PREPARED FOR THE PLAN COMMISSION

Project Address: 3520-3546 E. Washington Ave. (15th Aldermanic District, Alder Ahrens)
Application Type: Demolition, Conditional Use, and Rezoning
Legistar File ID #: [38734](#) and [39891](#)
Prepared By: City of Madison Planning Division
 Report Includes Comments from other City Agencies, as noted
Project Manager: Heather Stouder, AICP

Requested Action: Approval of a demolition of a vacant restaurant building and a conditional use for a convenience store with fuel sales in the Commercial Corridor Transitional (CC-T) District.

September, 2016 REVISED Site Plan

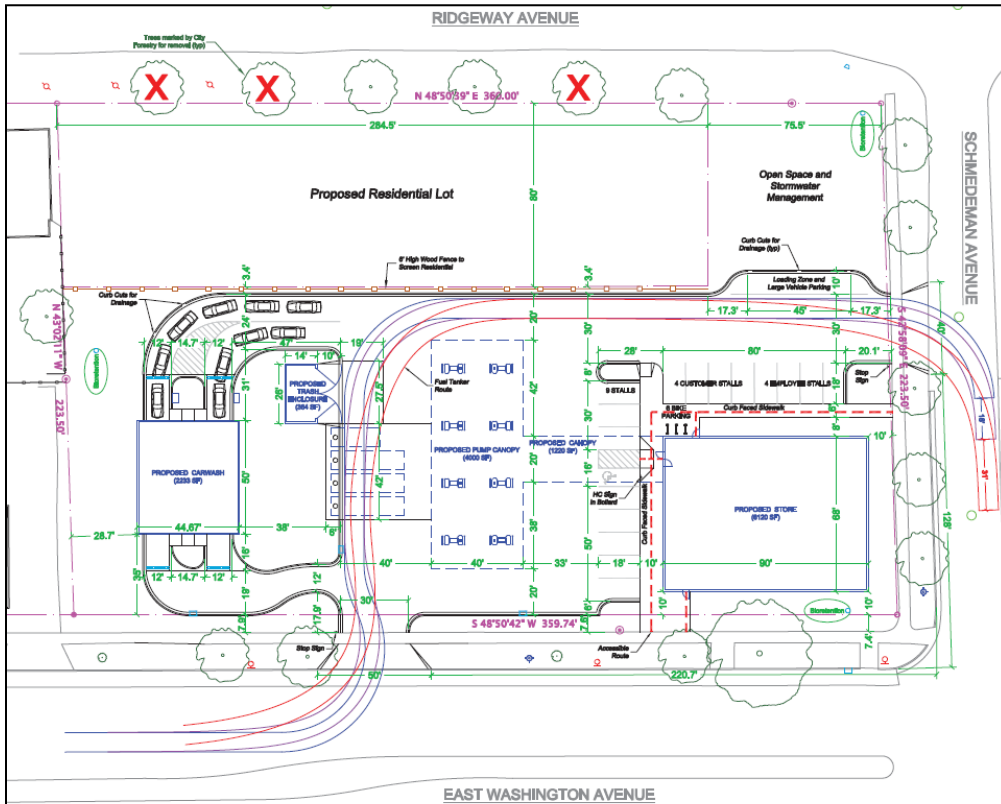
- The convenience store building has been shifted to the southeast corner of the site, with an entrance facing East Washington Avenue, and the fuel sales canopy is now in the central portion of the site.

- The increased efficiency in the use of the property and site plan changes result in a reduction in surface parking from a total of 35 potential stalls to 17 stalls.

- The entrance driveway off of Schmedeman has been shifted slightly to the south, allowing the preservation of an additional large street tree.

3. The applicant shall revise the site plan so as to include some of the bicycle parking near the southern entrance to the building facing East Washington Avenue.

22. Remove all landscaping and bioretention on sheet L1 from the East Washington Avenue Right of way.
23. The construction of this building will require removal and replacement of sidewalk, curb and gutter and possibly other parts of the City's infrastructure. The applicant shall enter into a City / Developer agreement for the improvements required for this development. The applicant shall be required to provide deposits to cover City labor and materials and surety to cover the cost of construction. The applicant shall meet with the City Engineer to schedule the development of the plans and the agreement. The City Engineer will not sign off on this project without the agreement executed by the developer. The developer shall sign the Developer's Acknowledgement prior to the City Engineer signing off on this project (MGO 16.23(9)c).
